FOURSQUARE AT STERLING RANCH EAST FILING NO. 1 GRADING AND EROSION CONTROL PLAN			
DESIGNED BY	DLG	SCALE	DATE 11-30-22
DRAWN BY	DLG	(H) 1" =	SHEET 2 OF 27
CHECKED BY	(V) 1" =	JOB NO.	1183.23

FOURSQUARE AT STERLING RANCH EAST
FILING NO. 1
GRADING AND EROSION CONTROL PLAN

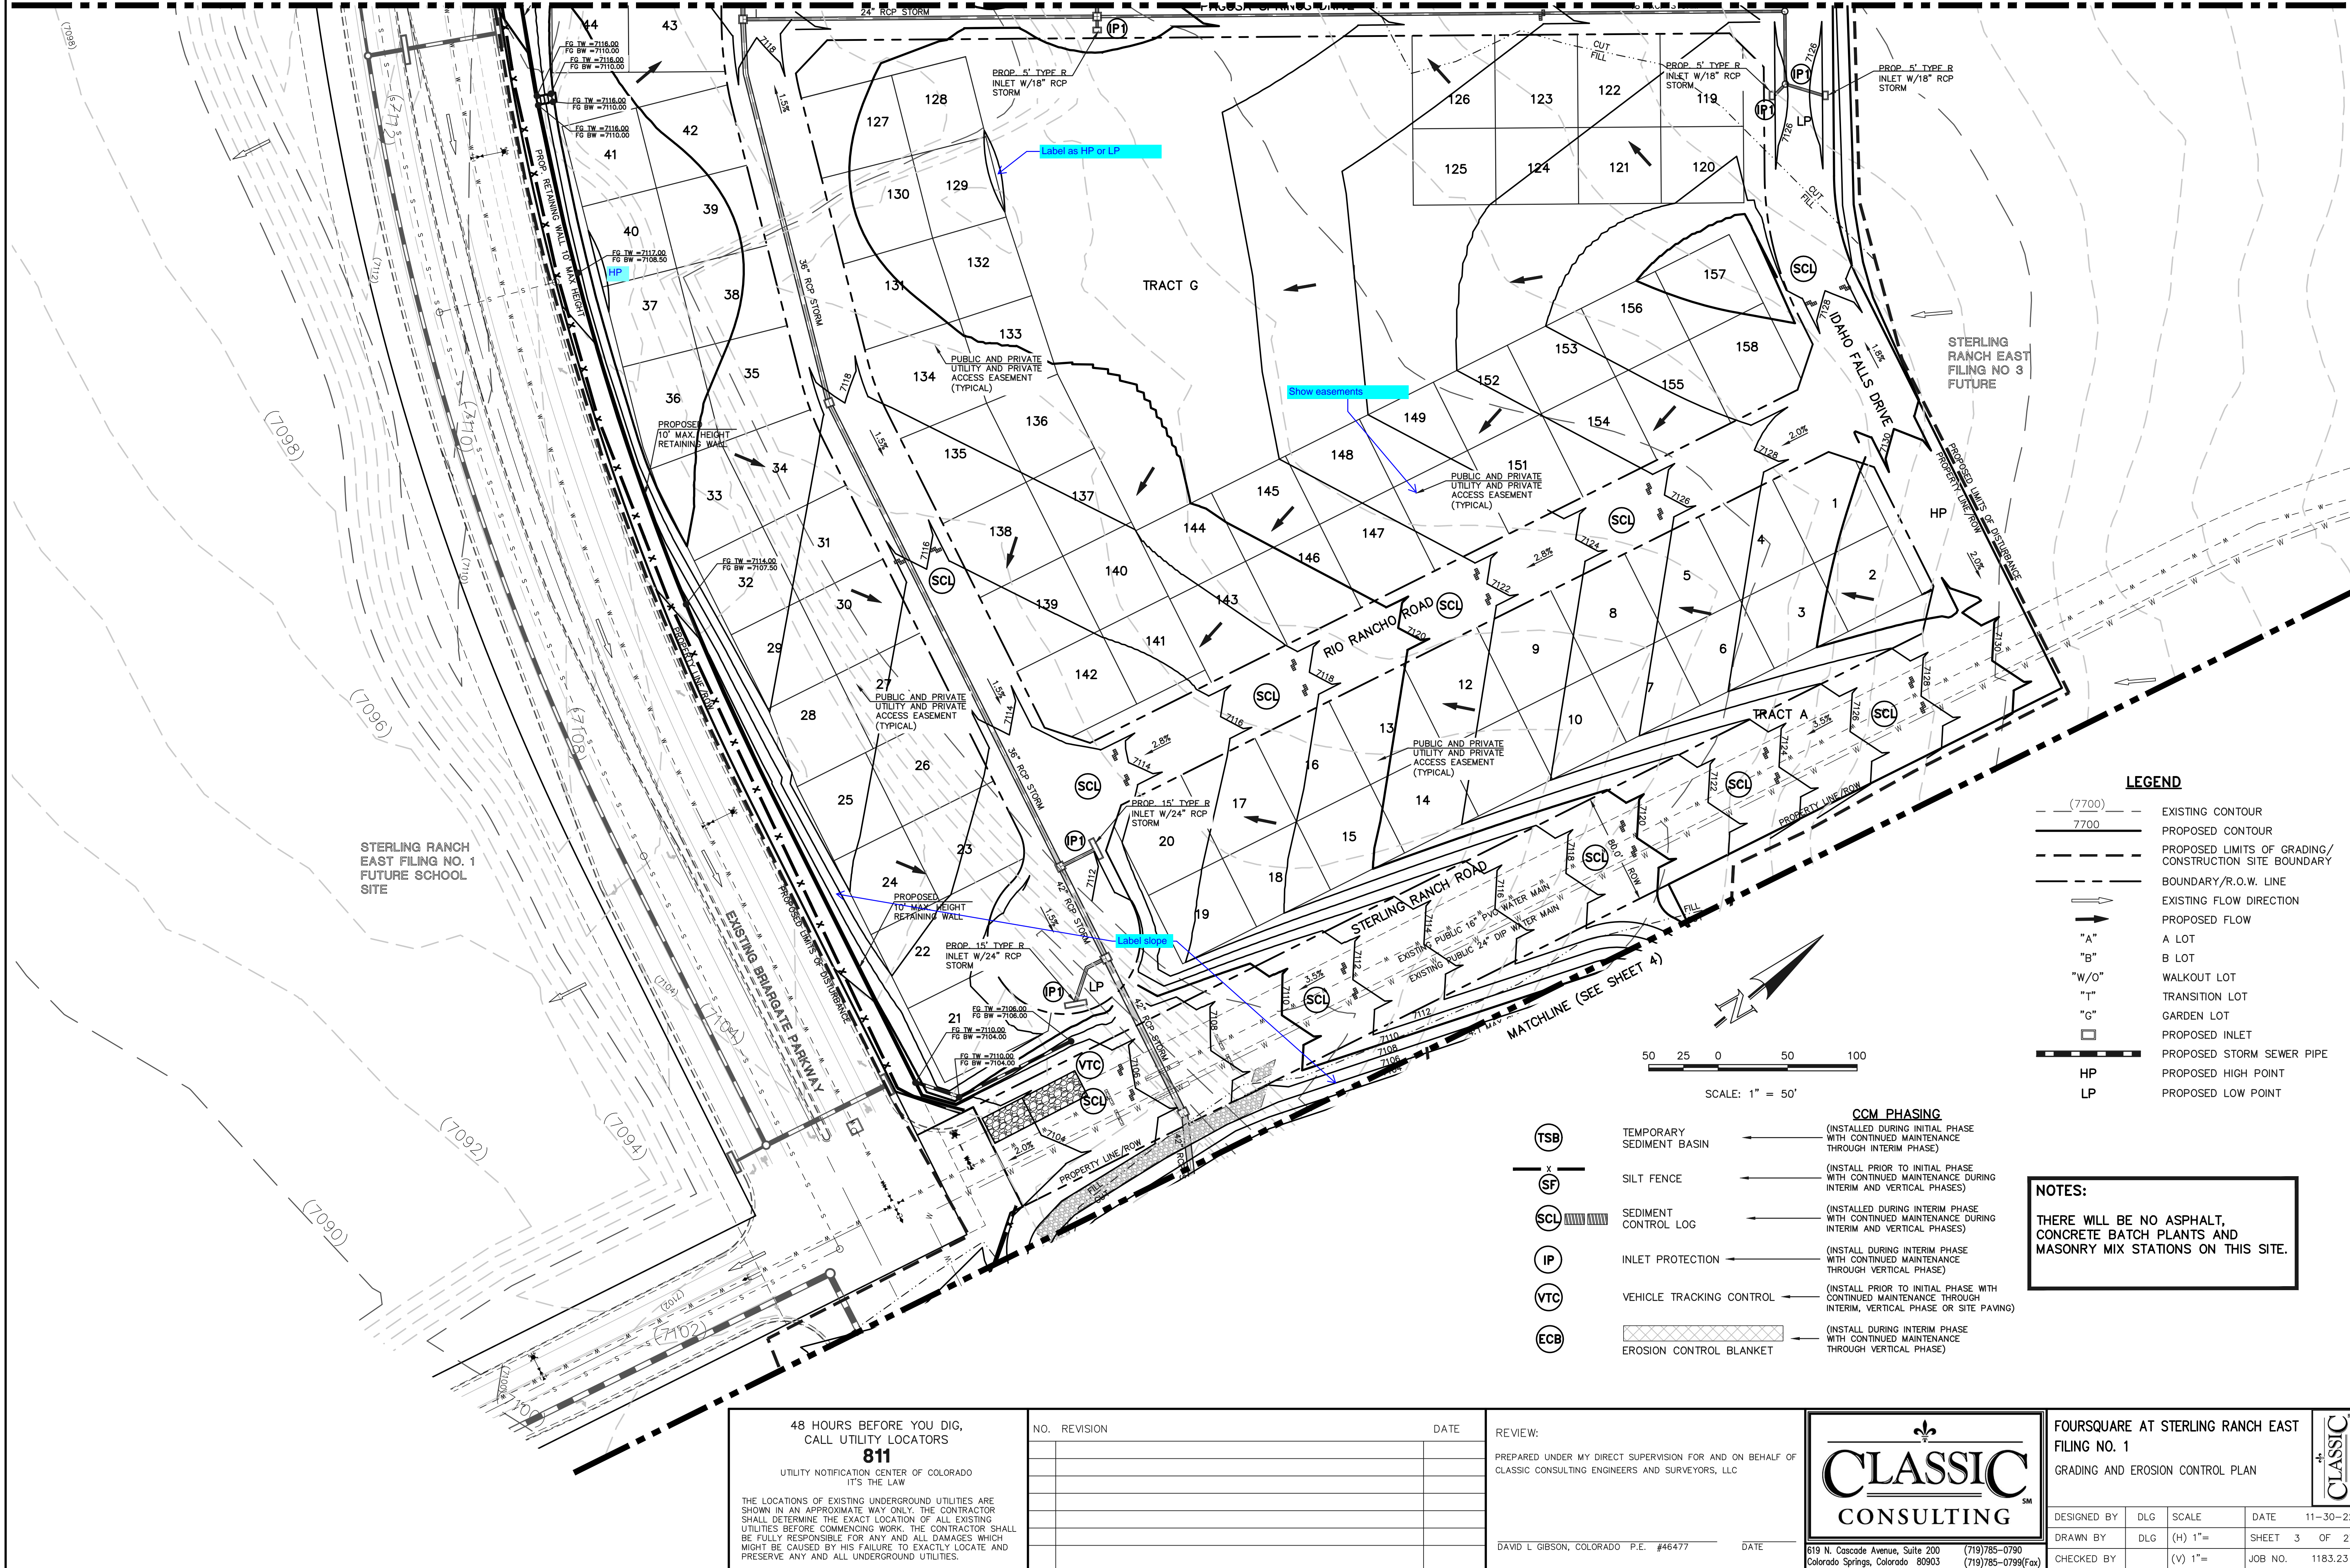
If these types of lot grading are not being done, remove from legend. If they are still relevant, include them on each lot and provide grading templates on GEC detail sheet.

Per GEC Checklist item "I" - add a note about the condition/type of existing vegetation.

For the following temp BMPs, add them to the Legend and then either to the plans or as a note stating that their locations are TBD by the contractor (or in certain cases like slopes >3:1 in the case of the ECB):

- CWA
- ECB
- Mulching
- Seeding
- Staging Areas
- Stockpiles

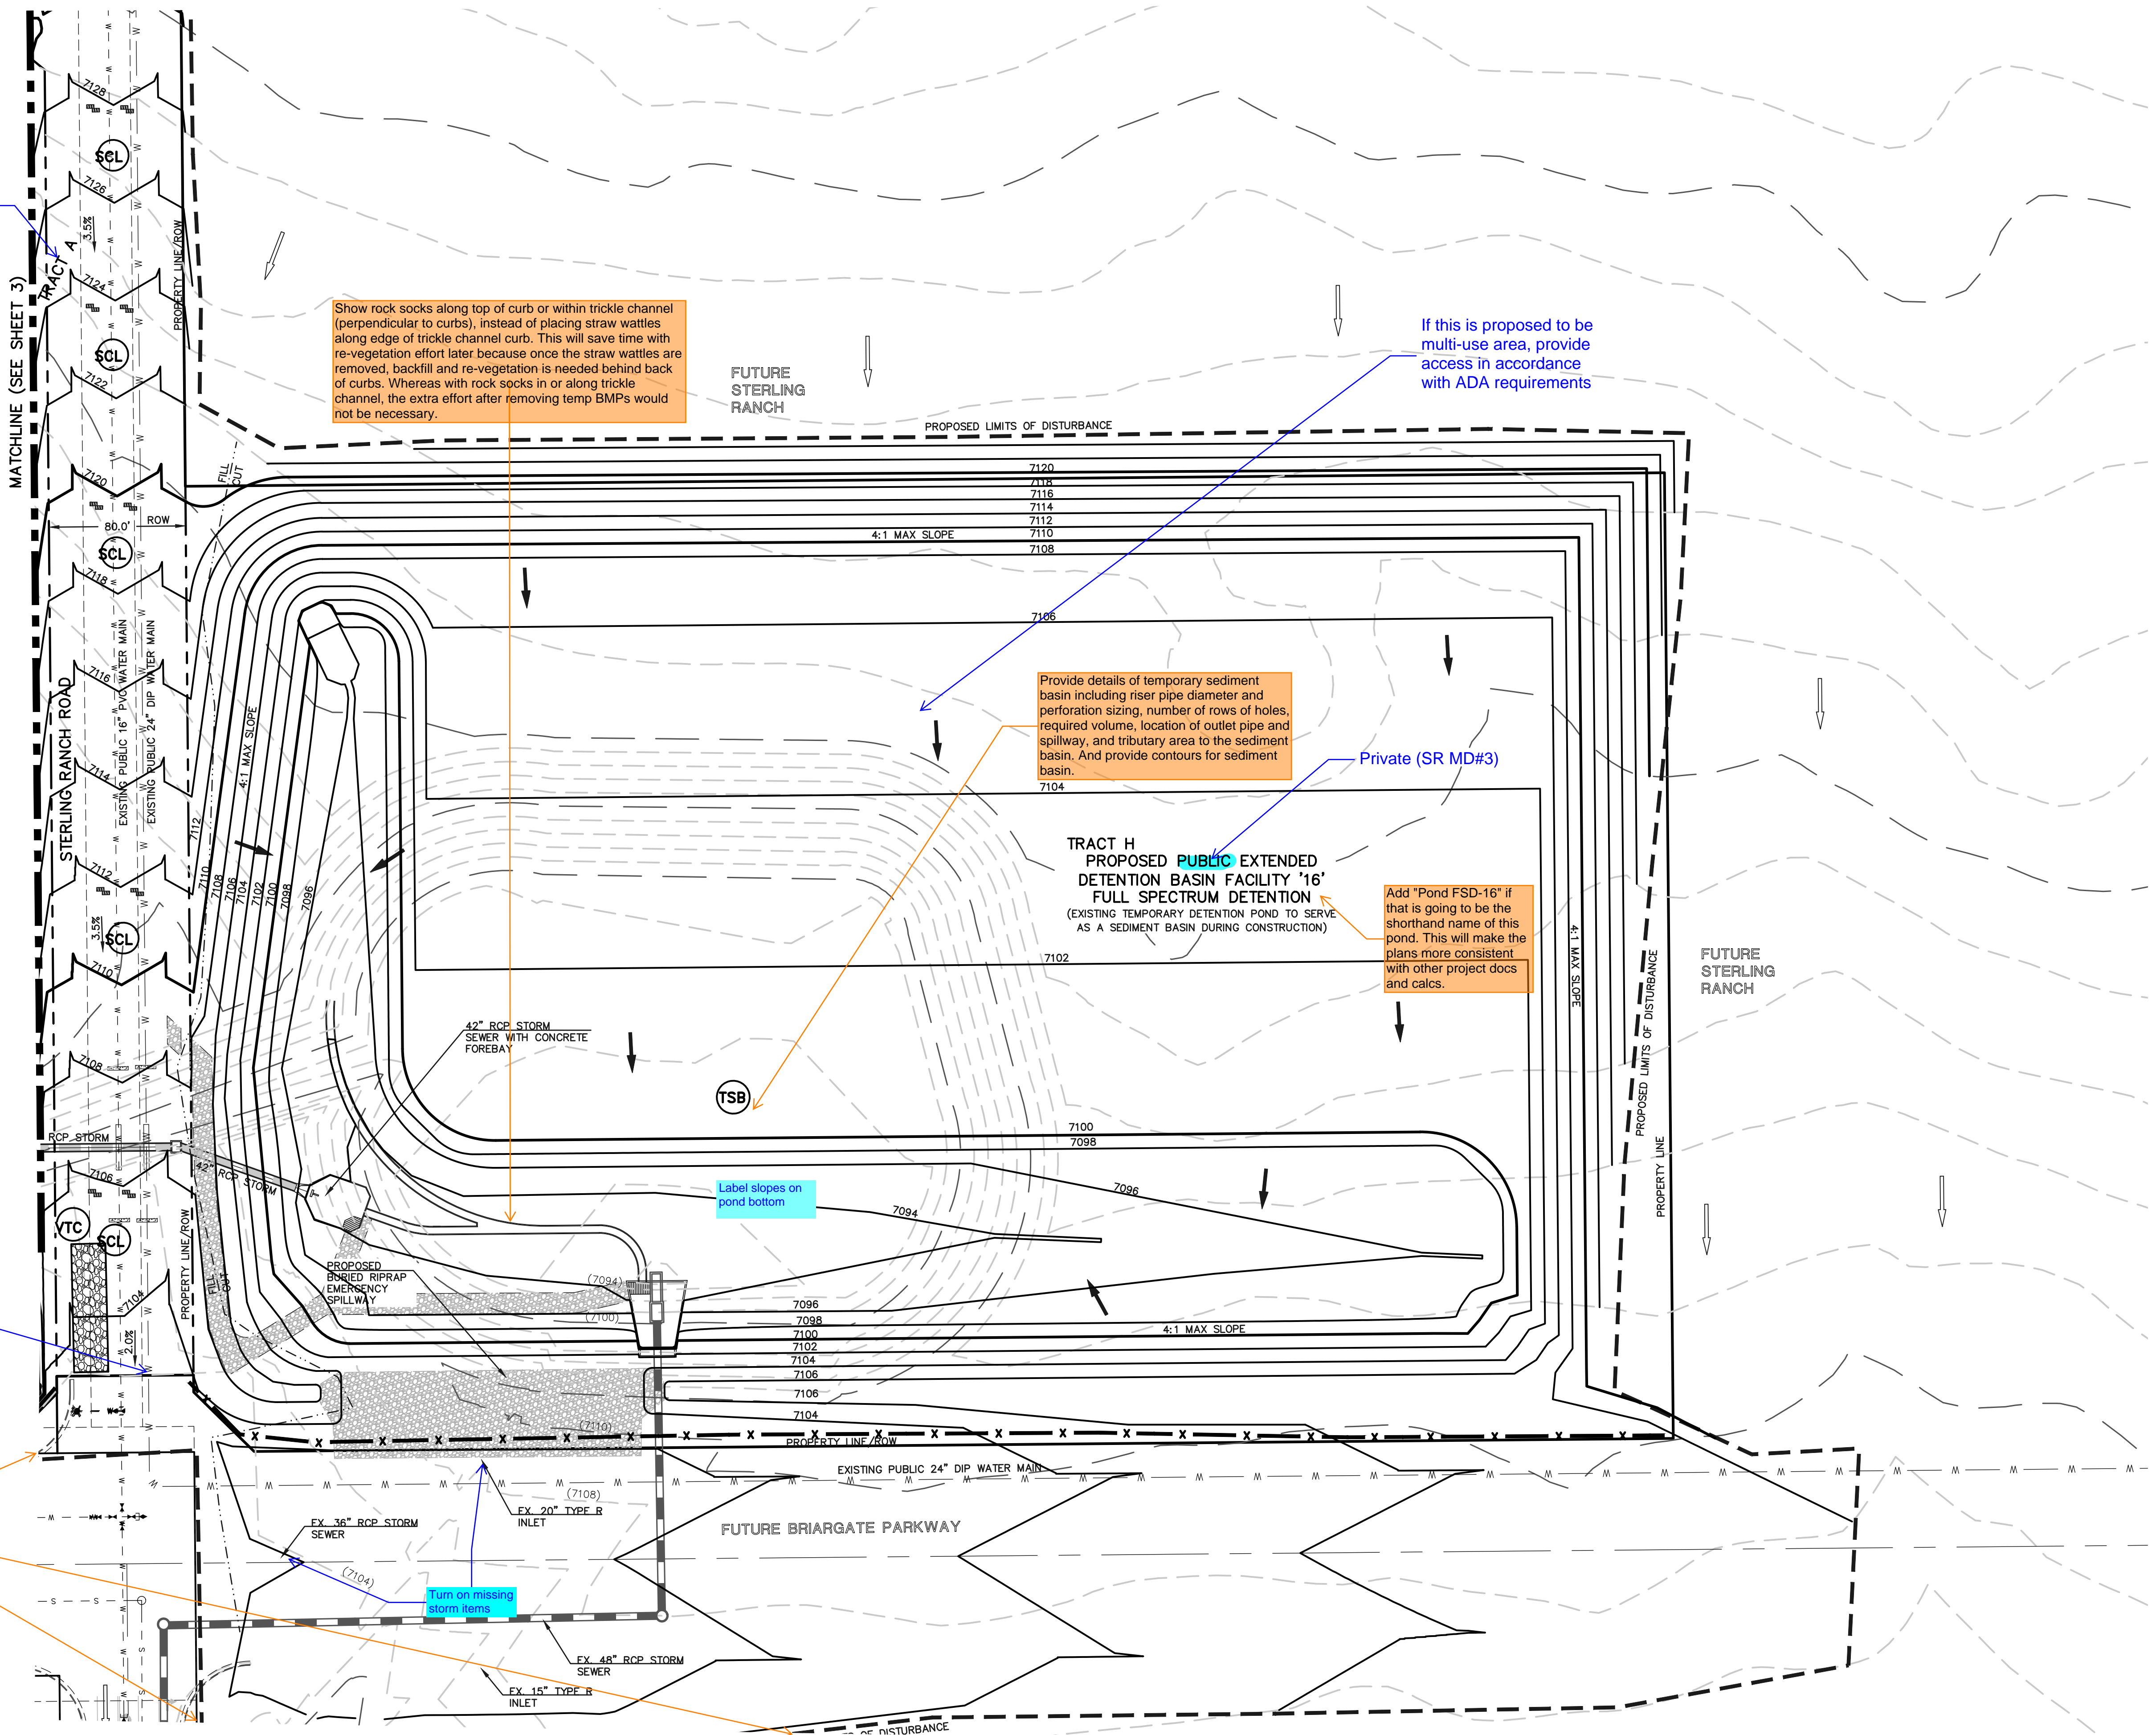
Delete label from this sheet

Show rock socks along top of curb or within trickle channel (perpendicular to curbs), instead of placing straw wattles along edge of trickle channel curb. This will save time with re-vegetation effort later because once the straw wattles are removed, backfill and re-vegetation is needed behind back of curbs. Whereas with rock socks in or along trickle channel, the extra effort after removing temp BMPs would not be necessary.

If this is proposed to be multi-use area, provide access in accordance with ADA requirements

Provide details of temporary sediment basin including riser pipe diameter and perforation sizing, number of rows of holes, required volume, location of outlet pipe and spillway, and tributary area to the sediment basin. And provide contours for sediment basin.

Add "Pond FSD-16" if that is going to be the shorthand name of this pond. This will make the plans more consistent with other project docs and calcs.

Verify road width per PUDSP comments

Label slopes on pond bottom

Revise viewport and/or LOD so that LOD is not cutoff.

Turn on missing storm items
